Project Memorandum

From: Gabriele Walser **Date:** August 3, 2020
Subject: Review of ADWR Salt River Valley Groundwater Model Application for
Resolution's Desert Wellfield - FINAL

Project No.: 1704007-06

Figure 4. Model boundaries.

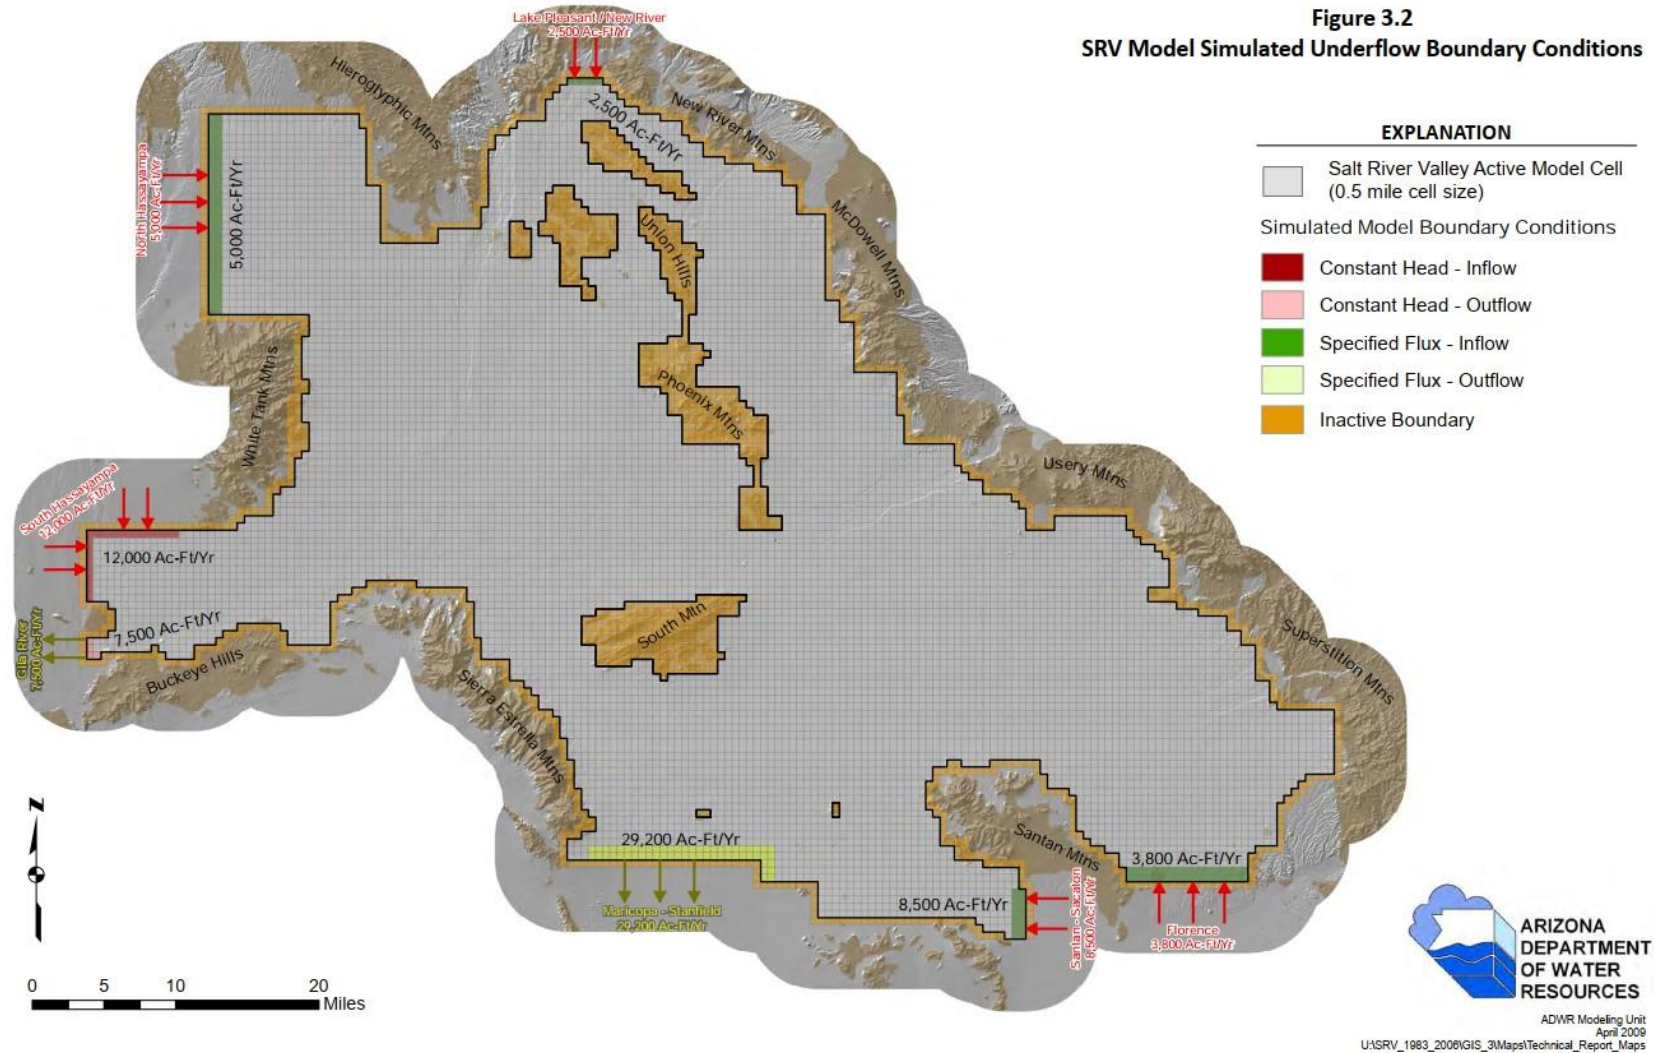
The ADWR Salt River Valley model has a specified flux boundary at the southern-most boundary of the model area near the Desert Wellfield, and no-flow boundaries on all other sides (Figure 4). Mountain front recharge is applied along the eastern no-flow boundaries. Measured head contours for baseline conditions in 2017 (no pumping in the Desert Wellfield), shown in M&A (2020b) Figure 1, indicate that the natural groundwater flow direction is from the mountains in the east towards the Desert Wellfield and then north towards the center of the Salt River Valley, in response to the mountain front recharge. This agrees with the conceptual flow direction established in ADWR (2009) and supports the use of the ADWR model for modeling the Desert Wellfield.

The lateral boundary conditions in the model (no-flow boundaries on all sides except the southernmost boundary, where a specified flux boundary is prescribed) are such that the head would change at the boundary if drawdown were to extend to the boundary. The drawdown contours shown in M&A (2020a, Figure 4) indicate that under maximum drawdown conditions, the drawdown does not extend to the boundary, and thus simulated drawdown at the Desert Wellfield is not significantly impacted by the model boundaries or domain size.
